STAFF REPORT

NEW BEDFORD HISTORICAL COMMISSION MEETING

LOCATION: 22 Centre Street (Map 53 Lot 191)

OVERVIEW: The property owner is seeking a modification to the Certificate of Appropriateness #2014.30, issued on 12.08.14 for the restoration and rehabilitation of 22 Centre Street.

Proposed example of *Allied Historic One Lite (HOL)* storm window

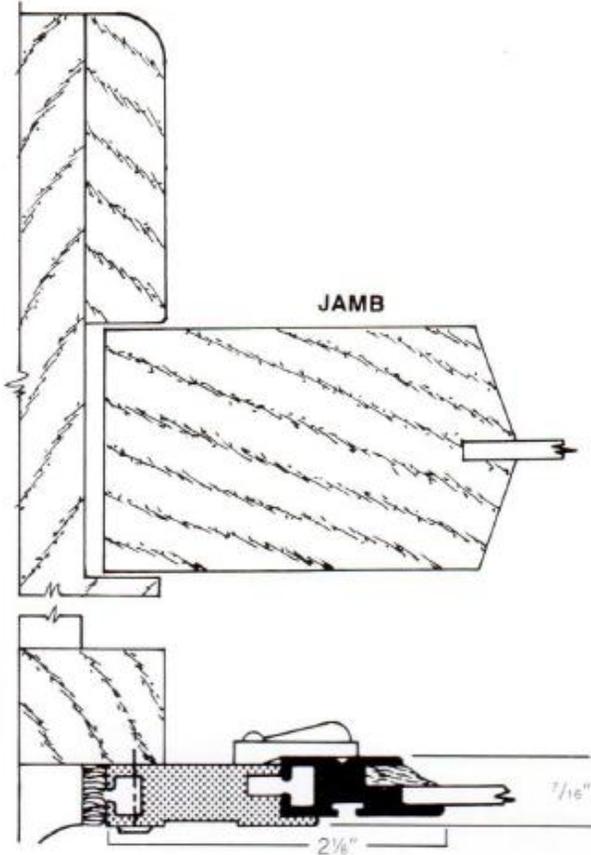
STORM WINDOW: The proposed storm window is a trim-lined aluminum product specifically designed for historic installations. The top part of the storm window is fixed and the bottom will have a removable screen. The storm will have a factory painted finish of off-white to closely match the painted wood sash (*Benjamin Moore, Arcadia White*) and the meeting rails will align to the sash. The glazing will be clear and there will be no UV films applied. The proposed storm window meets the requirements of the District Design Guidelines and staff recommends the granting of a Certificate of Appropriateness.

Proposed more period accurate
six-panel door

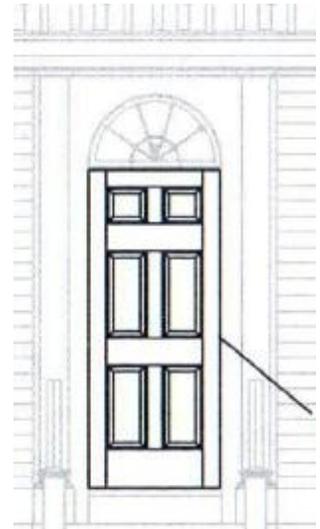
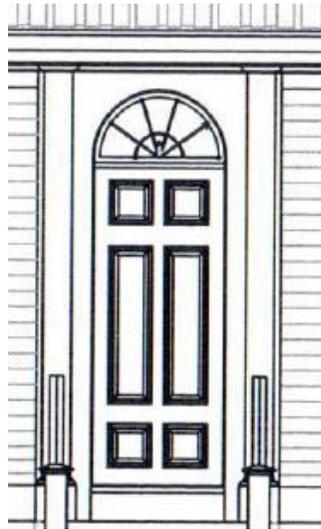
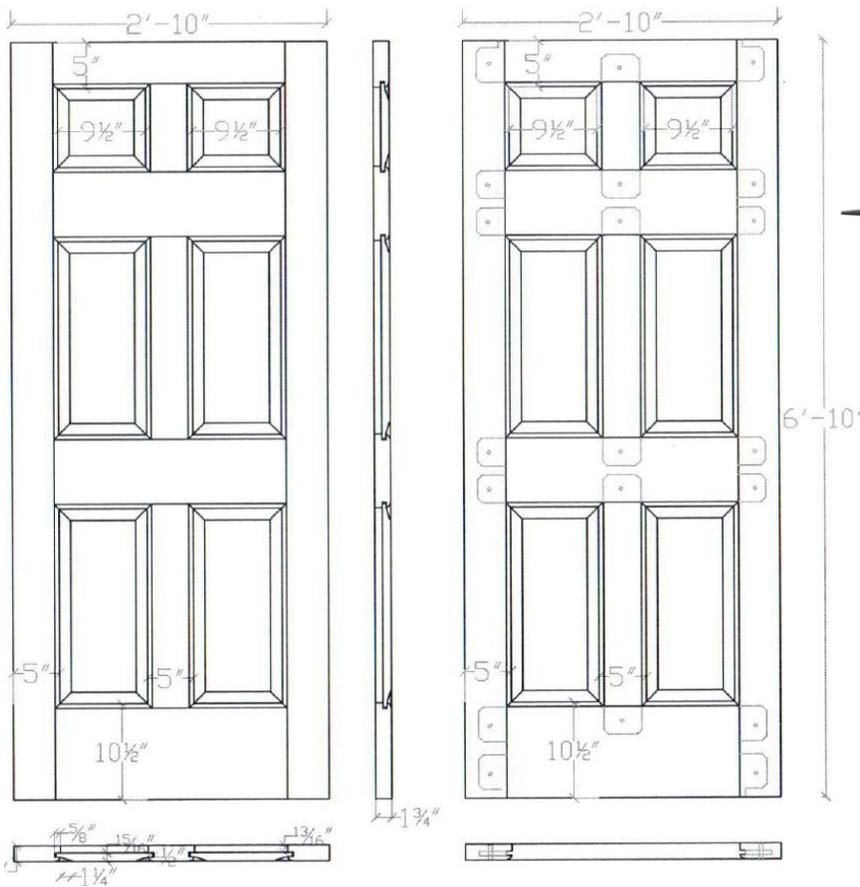
DOOR: The current six panel front door was installed in 1976. The proposed replacement is a six-panel, solid mahogany door, whose panel design is more accurately proportioned for the Federal period style of architecture. The door will be hung with hand forged, period accurate wrought iron hardware. The proposed door meets the requirements of the District Design Guidelines and staff recommends the granting of a Certificate of Appropriateness.
